SPECIAL COMMITTEE OF THE WHOLE - AUGUST 31, 2010

THE VAUGHAN METROPOLITAN CENTRE SECONDARY PLAN FILE: 25.5.12.1 WARD 4

To provide the technical report and recommendations from the Commissioner of Planning in regard to the comments received on the draft Vaughan Metropolitan Centre Secondary Plan (May 2010) emerging from the June 14, 2010 Public Hearing meeting.

SCHEDULE C > STREET NETWORK

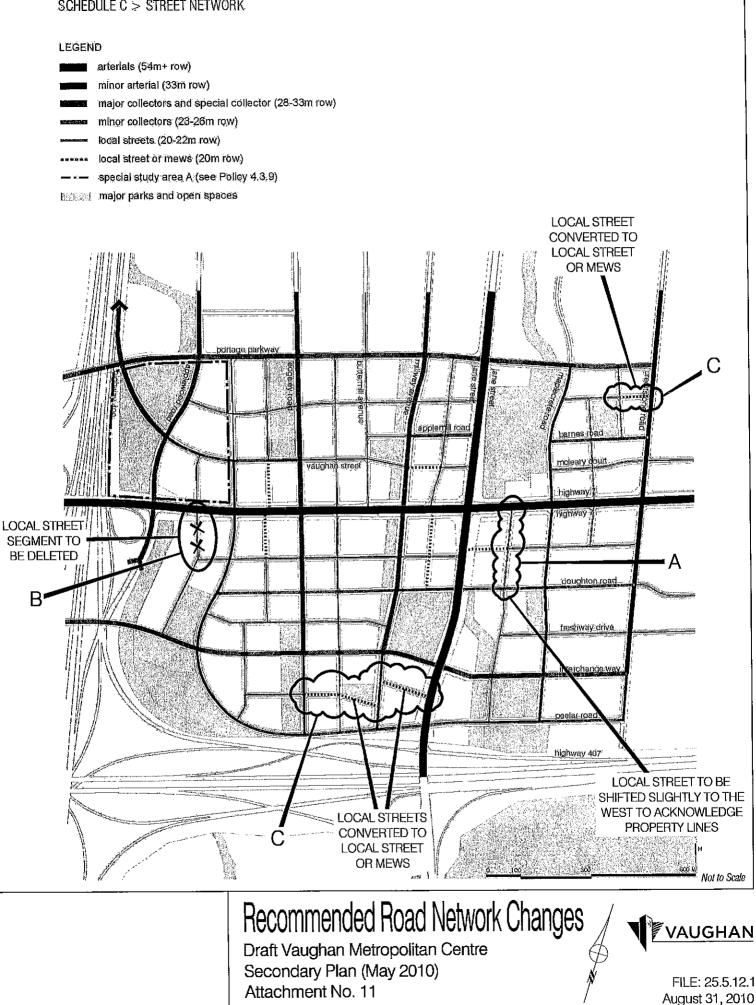
A number of respondents have commented that the VMC Secondary Plan road network is too detailed. Others have asked whether the road network, (including the proposed bypasses and Hwy. 400 Flyover connecting Colossus Drive and Interchange Way), has been studied to determine its viability. A fine-grain network of streets is critical to ensuring the VMC is transit and pedestrian-oriented. This system of roads also helps to disperse traffic and increase property frontage. The physical barriers within and adjacent to the VMC, including Highways 400, 407 and 7, pose challenges for movement to and within the VMC, which the proposed network seeks to address. To help secure the finer local road system, staff recommend that, "the density associated with the conveyance of a new street or mews may be transferred to the balance of the property on which the new street or mews is situated. The maximum height may be increased to accommodate the additional density, where appropriate".

SS.UB				 Need more flexibility with respect to location of local roads (Section 4.3.1). 	 Lands not in floodplain should not be subject to Special Study Area B (East) conditions. 	 Design policies in Section 8.6 and/appendix C.1 should be only guidelines. 	4) Section 6.1.3 related to Parkland too onerous.	 Section 10.0 Block Master Plan policies are too general- need to identify range of issues to address and approval process for Block Master Plans.

Minor modifications to the location and alignment of planned streets are permitted without amendment to the plan, as provided through Section 4.3.1 of the draft VMC Secondary Plan,

- a) A minor re-alignment of the north/south road to coincide with the westerly property boundary of the adjacent lands (lands located at southwest corner of Maplecrete Rd. and Hwy. 7).
- b) A section of the local street at the westerly boundary of the plan is to be removed because of grade issues at this location.
- c) Two additional local street sections in the southerly part of the plan, and one in the northeast part of the plan, are proposed as either roads or mews to permit greater flexibility at the development stages of the plan.

Recommendation				 That minor changes be made to the local road network as identified on Schedule 11 to this report. 	 That Section 8.4.3 be revised to state that: properties partially or wholly within Special Study Area B, but entirely 	outside the floodplain are exempted from the development restrictions applicable to lands in the study.	 No change is recommended. No change is recommended. 	5) That it be clarified in Section 10.0 that: Block Master Plans are required for individual city blocks, not concession
